Docket Number:	18-IRP-01
Project Title:	Integrated Resource Plan
TN #:	229744
Document Title:	Staff Paper - Review of City of Palo Alto Utilities' 2018 Electric Integrated Resource Plan
Description:	N/A
Filer:	Harinder Kaur
Organization:	California Energy Commission
Submitter Role:	Commission Staff
Submission Date:	9/16/2019 3:04:43 PM
Docketed Date:	9/16/2019

Review of City of Palo Alto Utilities' 2018 Electric Integrated Resource Plan

September 2019 | CEC-200-2019-016

Figure 1: Palo Alto and Energy Commission Energy Forecasts 2018-2030 (GWh)

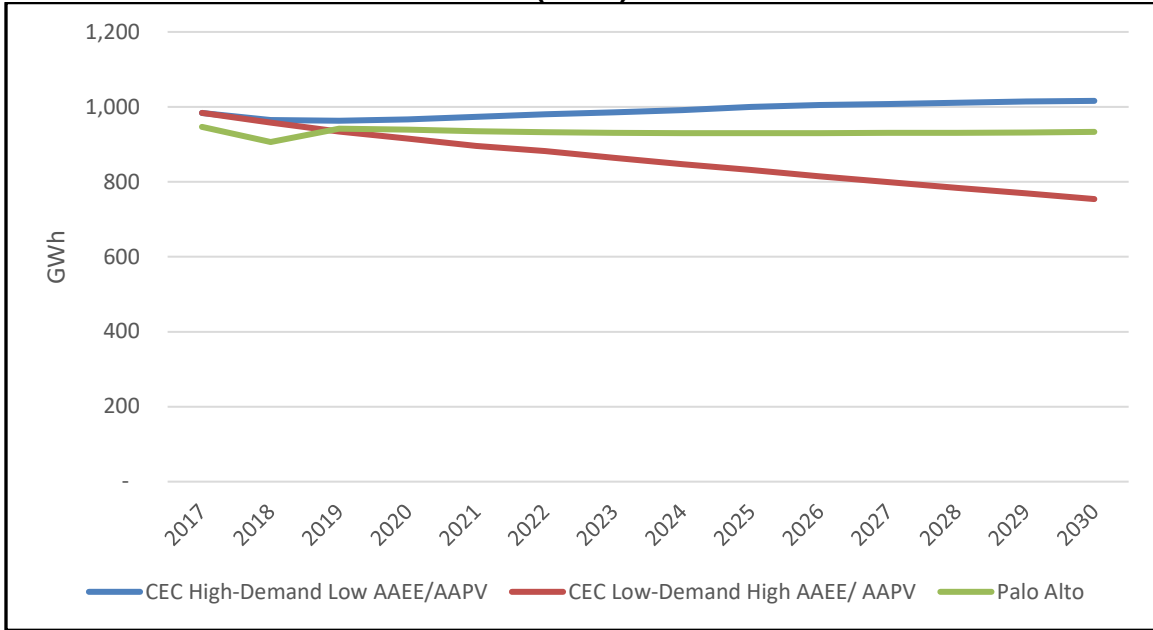
Staff compared Palo Alto's energy and peak demand forecasts to the CEC's *2018 Demand Forecast Update* report. As shown in **Figure 1**, Palo Alto's energy demand forecast lies between the CEC's high-demand low AAEE/AAPV (high)

forecast and the low-demand high AAEE/AAPV (low) forecast, and decreases slightly over the planning period (roughly 1 percent annual average decrease).

The utility's forecast accounts for variables that can reduce demand: increased energy efficiency, rooftop solar, demand response, and energy storage. The forecast also includes variables that can increase demand: increased EV load and electric heat and water pump usage. The utility's forecast appears reasonable for long-term planning, given it is similar to the CEC demand forecasts.

Figure 2: Sources of Renewables Portfolio Standard Eligible Energy 2019–2030 (MWh)

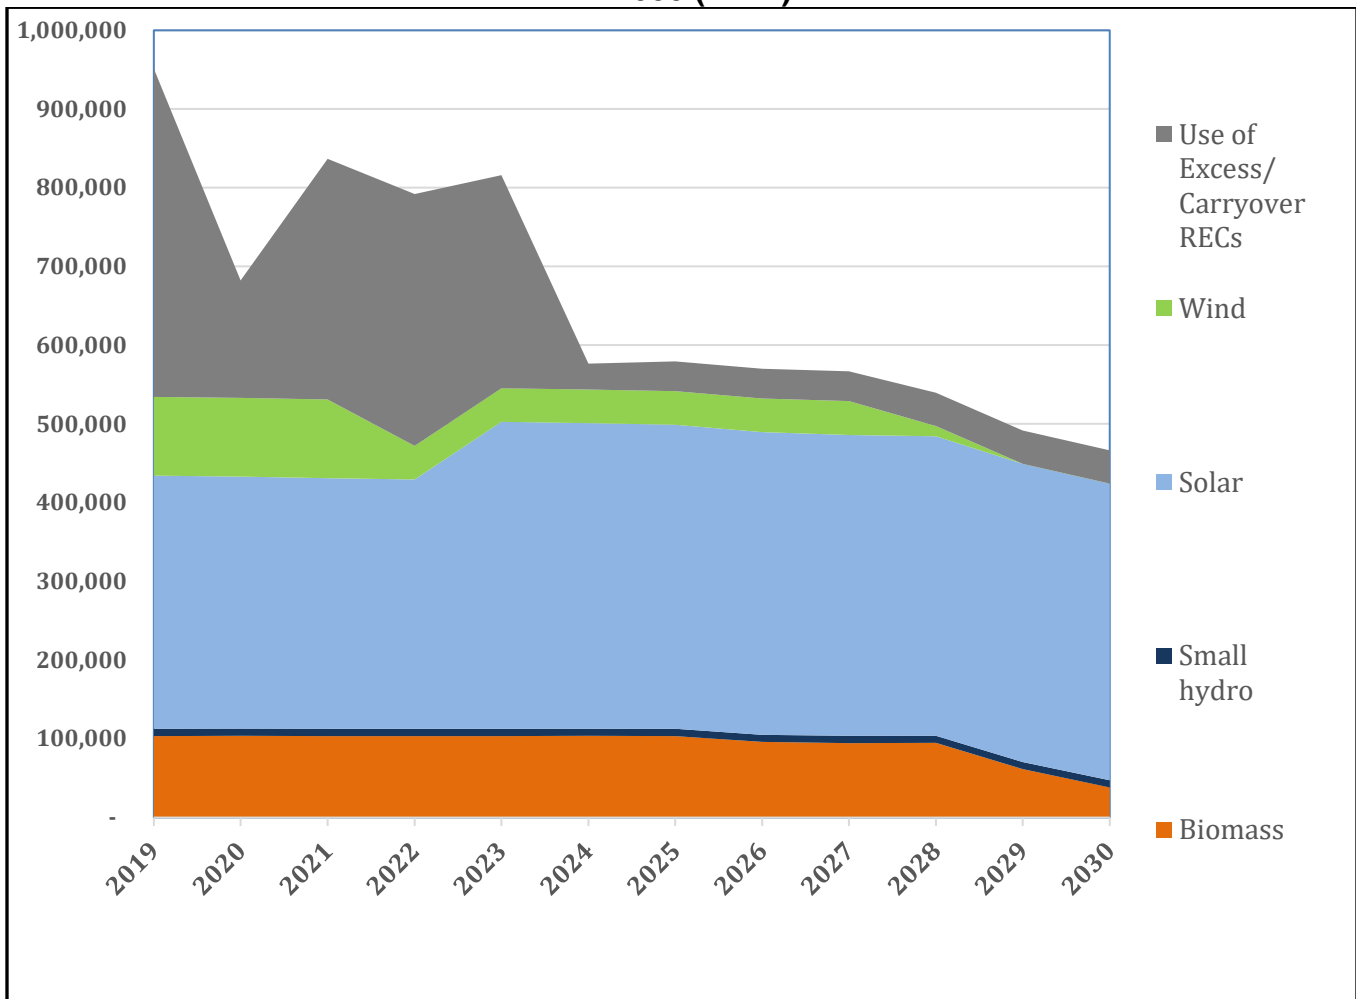
Figure 2 and **Figure 3** show Palo Alto’s renewable portfolio consists primarily of solar, with some landfill gas, small hydro, and wind. In 2019, solar makes up 60 percent of Palo Alto’s renewable resources, and by 2030 it makes up 89 percent.
